PG&E Letter DCL-06-008

Docket No. 50-275, OL-DPR-80
Docket No. 50-323, OL-DPR-82
Diablo Canyon Units 1 and 2
License Amendment Request 06-01
Revision to Technical Specification 1.1, "Definitions," and Technical
Specification 3.4.16, "RCS Specific Activity"

Figure 3.4-1
DOSE EQUIVALENT I-131 REACTOR COOLANT SPECIFIC ACTIVITY LIMIT
VERSUS PERCENT OF RATED THERMAL POWER WITH THE REACTOR COOLANT
SPECIFIC ACTIVITY > 1 µCi/GRAM DOSE EQUIVALENT I-131

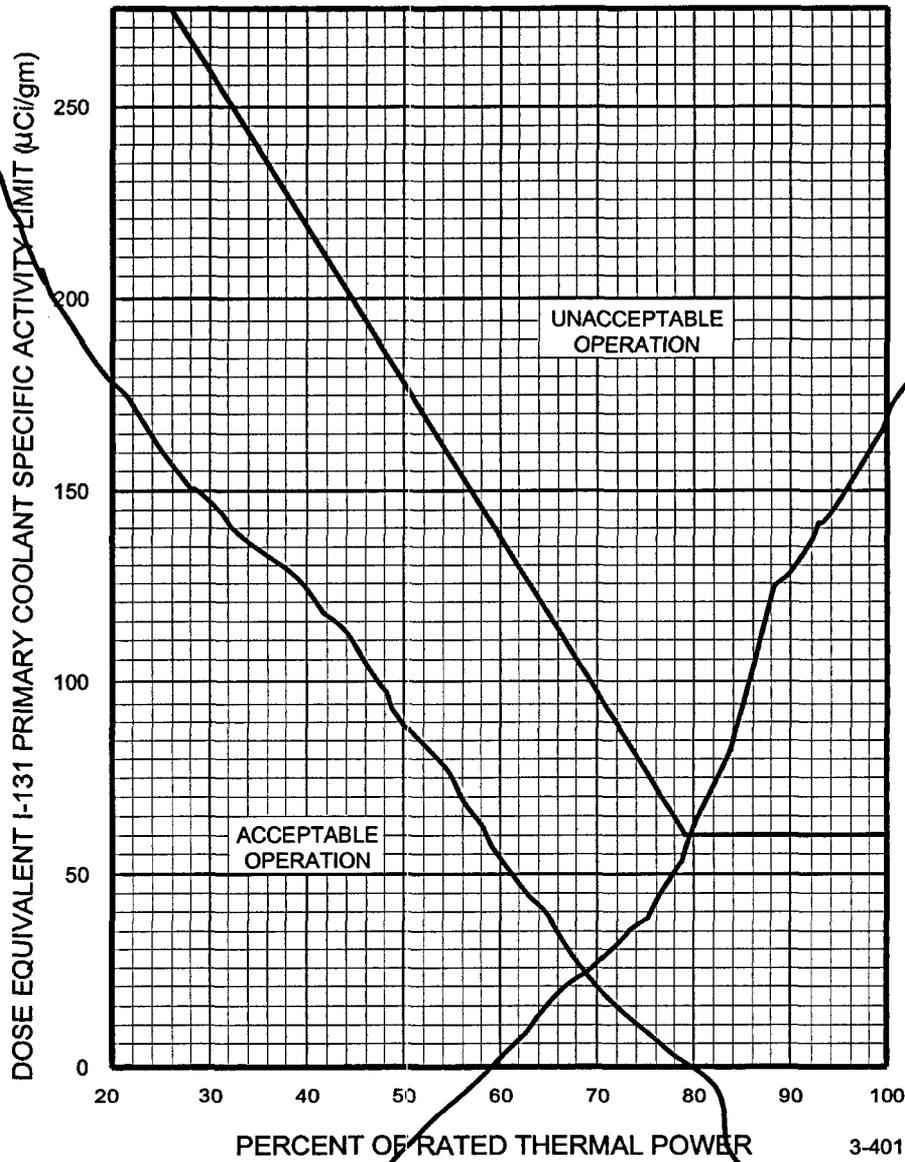
The current TS Figure 3.4.16-1, "Dose Equivalent I-131 Reactor Coolant Specific Activity Limit Versus Percent of Rated Thermal Power with the Reactor Coolant Specific Activity > 1 μ Ci/gram Dose Equivalent I-131" would be deleted.

TS 3.4.16 Required Action A.1 is modified to remove the reference to Figure 3.4.16-1 and insert a limit of less than or equal to 60 $\mu\text{Ci/gm}$ for DEI.

The curve contained in Figure 3.4.16-1 was initiated by the AEC in a June 12, 1974, letter from the AEC on the subject, "Proposed Standard Technical Specifications for Primary Coolant Activity." However, this letter does not provide any technical basis for the curve.

The Case 2 radiological consequence analyses for SGTR and MSLB accidents that take into account the preaccident iodine spike do not consider the elevated RCS iodine specific activities permitted by current TS Figure 3.4.16-1 for operation at power levels below 80 percent RTP (i.e., DEI of 60 $\mu\text{Ci/gm}$ at 80 percent RTP increasing linearly to [275] $\mu\text{Ci/gm}$ at [25] percent RTP). Instead, the Case 2 analyses assume a DEI concentration 60 times higher than the corresponding accident's Case 1 analysis assumption, [which corresponds to the 60 $\mu\text{Ci/gm}$ specific activity limit associated with 100 percent RTP operation as discussed in Section 3.1 above]. Therefore, TS 3.4.16 Required Action A.1 should be

based on a limit of 60 $\mu\text{Ci/gm}$ to be consistent with the assumptions contained in the radiological consequence analyses. It is not expected that plant operation at reduced power levels would result in iodine specific activity levels that exceed the 60 $\mu\text{Ci/gm}$ upper limit defined for full power operation.
